Jagg oil filter adapter gaskets

Background: Over the years there have been a few revisions to the 4600/4700 offset oil filter adapters that have necessitated changes to the gasket patterns.

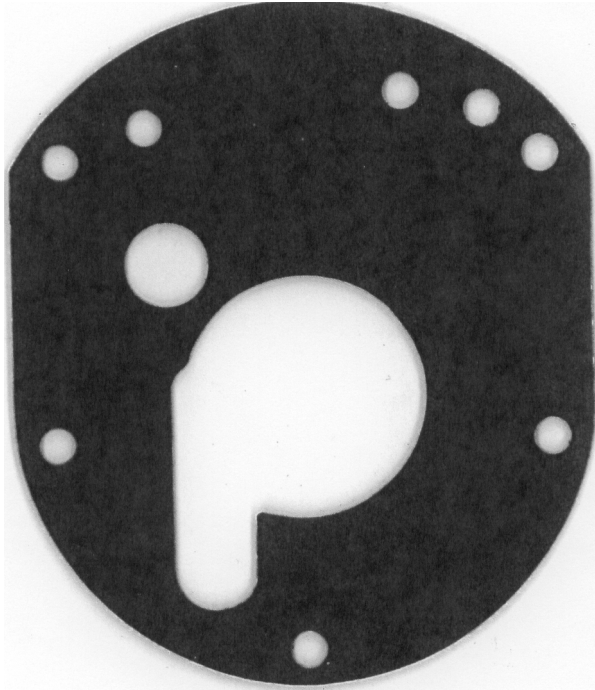
This gasket was produced for the first revision of the 4600 and the introduction of the 4700 offset oil filter adapters from early 2002-late 2003. First produced in Nitrile rubber, it was recreated in AFM (Aluminum Foamette Material) in late 2003 to replace the original Nitrile gaskets that were found to squeeze out of position after time.

The revised 4600 and new 4700 used #8-32 screws until changed to #10-24 screws in late 2002.
